**Canterbury-Bankstown Council Submission –
Exempt and complying development within existing cemeteries**

CATHOLIC METROPOLITAN CEMETERIES TRUST SUBMISSION – PROPOSED EXEMPT AND COMPLYING CODE FOR CEMETERIES

**Submission on Explanation of Intended Effect –
Exempt and Complying Development within Existing Cemeteries**

Submission to Explanation of Intended Effect – Exempt and Complying Development Framework for Cemeteries

Figure 1 Heritage Curtilage, McCarthur Memorial Park, Varroville

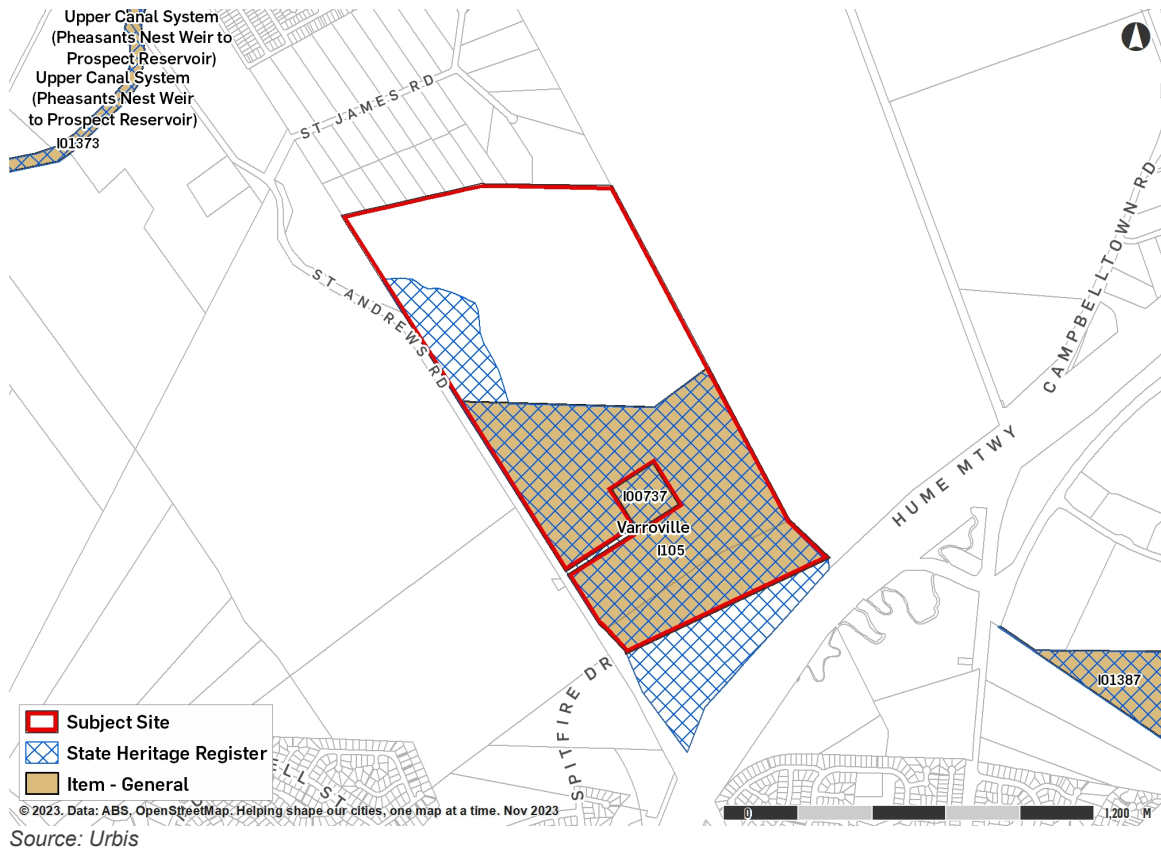
This EIE provides for specified minor works to be undertaken as exempt development if they have no more than minimal impact on heritage significance. However, we note that several of the exempt development items cannot be undertaken within the *curtilage of a heritage item*- i.e., driveways, hardstand and carparks, decks terraces and pergolas, and sheds, maintenance facilities and carports all have this additional stipulation. We understand that these types of development are considered to have the potential for greater impact and therefore this additional safeguard has been added.

However, the term is spatially nonspecific and ambiguous. The terminology is also closely associated with the mapped area around a State heritage item which may lead to confusion. This exclusion has practical implications if the heritage listing applies to the whole site, and not just to individually identified items within a site.

An example is Macarthur Memorial Park which is currently under construction (Refer to **Figure 1**) below.

A large proportion of the Varroville site is mapped as a locally listed heritage item 'Varroville Estate'. On this part of the site the current wording in the EIE would mean that certain exempt development types would still require a development application. This would be the case even if the work was a type for which an exemption was provided under Section 57(2) of the Heritage Act 1977. This creates statutory confusion for the consent authority and would have time-consuming and costly implications for CMCT. This is a live example at Macarthur Memorial Park, with CMCT having to recently lodge a modification application to their cemetery approval to replace boundary fencing.

Recommendation: Explore alternative wording to the term 'curtilage' to facilitate greater flexibility for all types of development that are subject to site wide heritage listings. It would be preferable to require an internal assessment process rather than apply this blanket exclusion.

Figure 1: Typical Crypt and Mausoleum Building

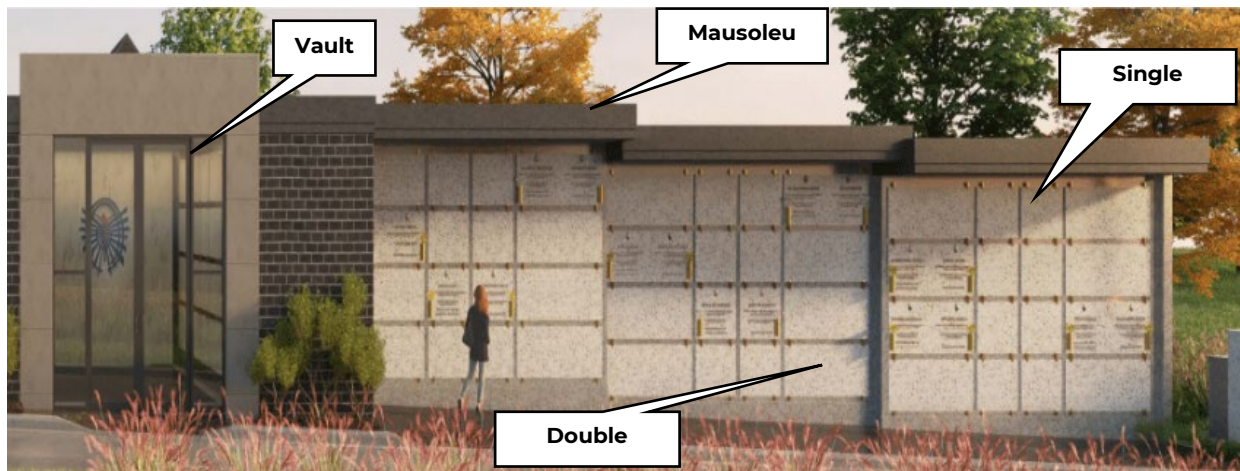
MMP considers that there is a misunderstanding of how a crypt is delivered, based on the proposed development standards. Although a single crypt may be of a size that is consistent with the proposed development standards of this section (maximum building footprint of 25m² and maximum building height of 7m), MMP construct large mausoleum structures with numerous crypts, often extending to a 200m² building footprint, which are then sold to community on demand. The development standards of this section envision that crypts are constructed on an individual as needs basis which is not the case and importantly would be totally inefficient from a construction perspective. Refer to Figure 1.

That the development standards for Vaults, Crypts, Sculptures (Including Monuments and Memorials), Headstones, Artwork, Columbariums be revised as follows:

Figure 2: Macquarie Park Cemetery and Crematorium – Section 4.55 Modification Application For Minor Works (shaded yellow)

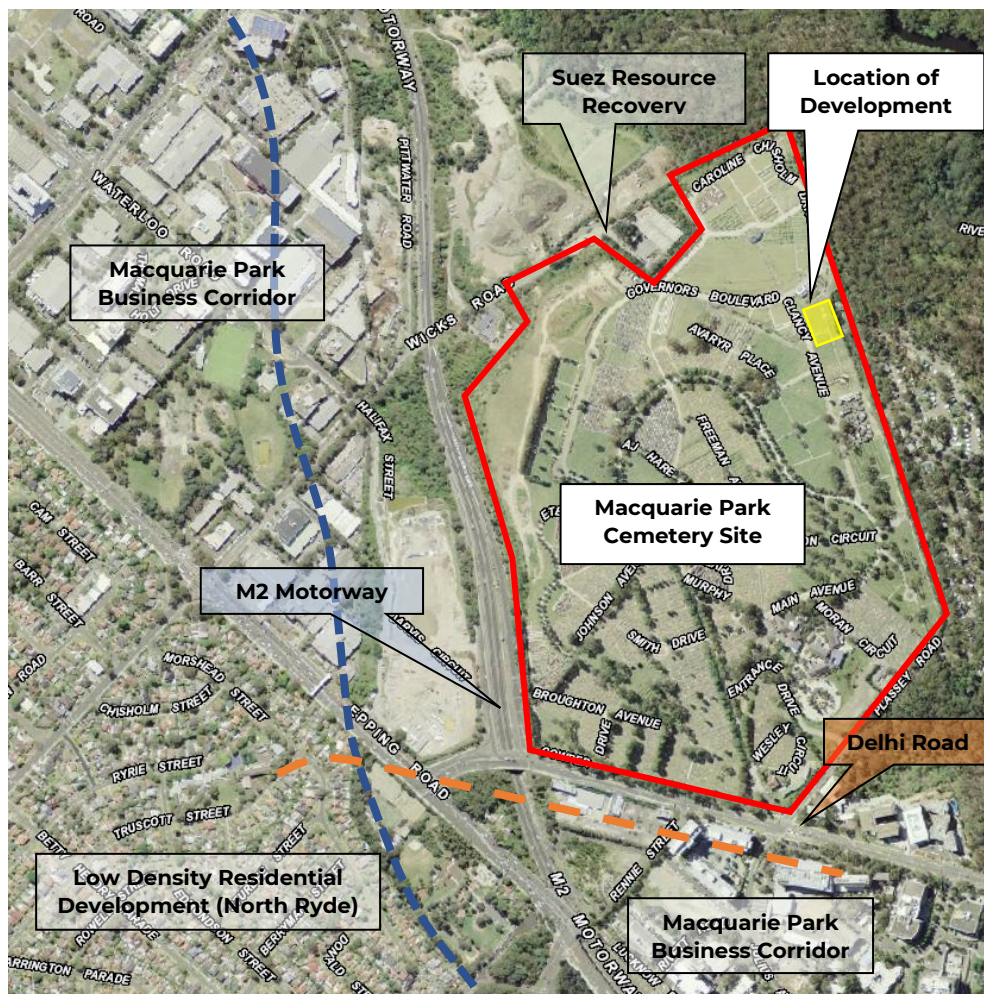
A Section 4.55 Modification Application was lodged to Ryde City Council for minor works to the Macquarie Park Cemetery and Crematorium cemetery which involved the deletion of an internal access road, upgrades to pedestrian access and the installation of six new family vaults. Refer to **Figure 2**, **Figure 3** and **Figure 4**. The total cost of proposed works was approximately \$1.6 million.

The Council assessment time for the Modification Application was 98 days between 6 September 2021 and 13 December 2021. The original Development Application LDA2018/0338 sought approval for the construction of a single storey mausoleum with 650 crypts and five family vaults, a single storey chapel, two amenity buildings for the mausoleum and chapel, and landscape works. The assessment time required by Ryde Council for the DA was 218 days, between 23 August 2018 and 29 March 2019. The total assessment timeframe to facilitate an approval for the modified development (DA and Section 4.55 Modification Application) was 316 days, for what is typical ancillary development within the existing cemetery to better accommodate the intended cemetery use of the SP1 Special Activities – Cemetery zoning of the land.

Although the new family vaults and footpath are proposed additions, these components have been specifically designed so that they are directly connected to and form part of the approved development being one single Mausoleum development containing both crypts and vaults as well as an associated Chapel building for funeral services as approved under Development Consent No. LDA/2018/0338.

Based on the proposed controls in the new framework, the DA approval pathway would still be required to deliver the approved modified development, with the exception of the construction of the footpath and landscaping works. This demonstrates the limitations of the Department's proposed framework, which continues to deny cemetery operators with a much needed fast track pathway for minor works in cemeteries without the need for a Development Application and lengthy assessment timeframes.

Figure 5: Staging Plan of Proposed Works at Sandgate Cemetery

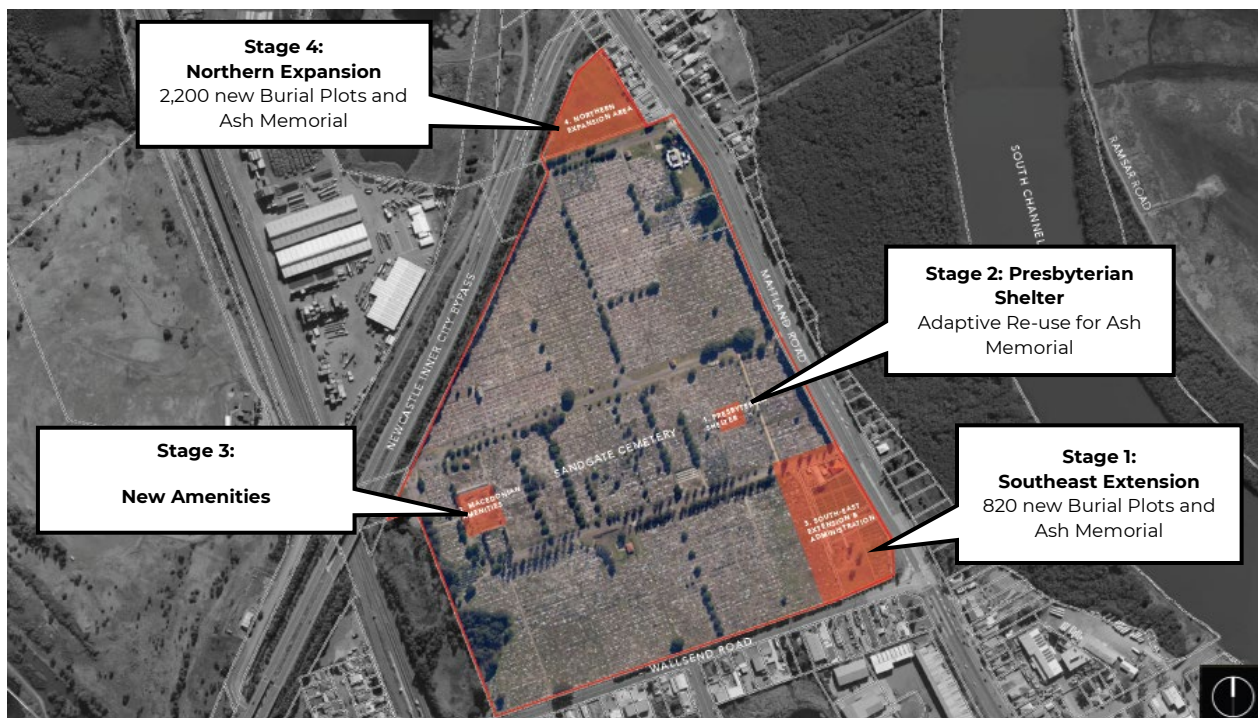
MMP is currently coordinating the lodgement of a Development Application with City of Newcastle for a blanket approval to facilitate minor development works in stages over the next 1-5 years. These works comprise urgent works that are required to the cemetery, which is a heritage listed site and has been operating as a cemetery since 1881. **Table 2** describes the works that are proposed under this DA. The works shaded red, notwithstanding the proposed framework (EIE), show that certain development types will still not be able to be undertaken as exempt or complying development and will still require a DA to be lodged to Council.

- Further delays in the delivery of critical infrastructure in response to need and demand;
- Additional consultant costs, statutory fee costs and staff resources required to manage the DA co-ordination process by MMP; and
- Unnecessary use of crucial town planning resources within City of Newcastle Council to carry out the assessment of what is considered a straight forward DA on an existing cemetery of minimal environmental impact.
